## #23-NA-209: Oil Can and/or Pop Noise from Roof Area During Car Wash - (Feb 25, 2025)

Subject: Oil Can and/or Pop Noise from Roof Area During Car Wash

Version	4
Modified	Released January 25, 2024 Revised March 18, 2024 – Added 2024 Model Year. Revised February 07, 2025 – Updated service procedure to add steps to install Roof Bow and supporting information. Revised February 25, 2025 – Added Vehicle Build Date Breakpoint.

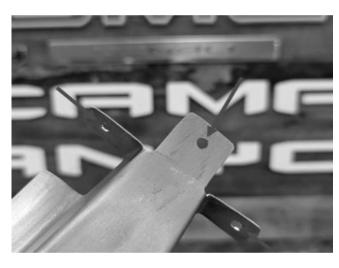
2. If the vehicle has already had the 5 stiffening panels installed to the underside of the roof panel in the RED locations in the illustration above, proceed to step 4. It is not necessary to remove any of the stiffening panels that have been previously installed before installing the roof bow.

3. Once the headliner is dropped (but not removed) apply the 2 stiffening panels to the underside of the roof panel in the RED locations in the illustration above.

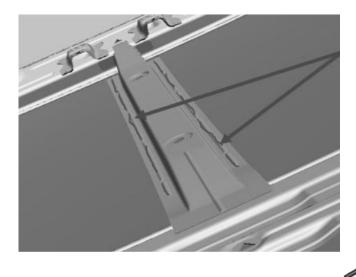
- 5. Using magnets to hold the roof bow in the proper position (Align the center line of the roof bow to the center line of the triangles in roof bars as shown in the above image).
  Drill holes in the underside roof structure using the pre-drilled roof bow as a template- and using depth control device on bit.
- 6. Remove the roof bow.

7. Apply crash durable structural adhesive Fusor 2098 or equivalent as called out in the graphic with a 3mm width of wet out along both ends.
